Discontinuation and Replacement of Heat Shield and Welding Adaptor for Oxygen Sensors

MOTORTECH is announcing the discontinuation and replacement of the following items:

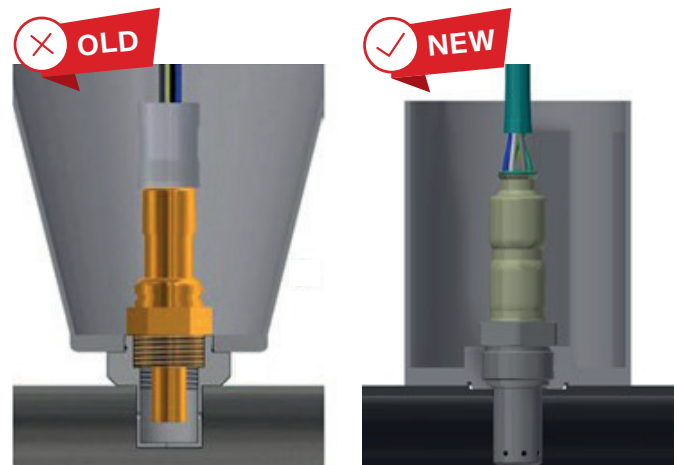
The heat shield is replaced by a new version that can be used with 2 types of welding adaptors for oxygen sensors (M18 thread) and NO_x sensors (M20 thread).

P/N	Description	Supersedes
07.81.076	Heat shield for NO _x sensor/oxygen sensor, inner thread M30x1,5, outer diameter 63.5 mm, height 80 mm	19.60.022
07.81.081	Welding adaptor for heat shield P/N 07.81.076, outer thread M30x1,5, inner thread M18x1,5, for oxygen sensor (e.g. P/N 19.60.004 & 19.60.015)	19.60.023
07.81.077	Welding adaptor for heat shield P/N 07.81.076, outer thread M30x1,5, inner thread M20x1,5, for NO _x sensor (e.g. P/N 56.03.003)
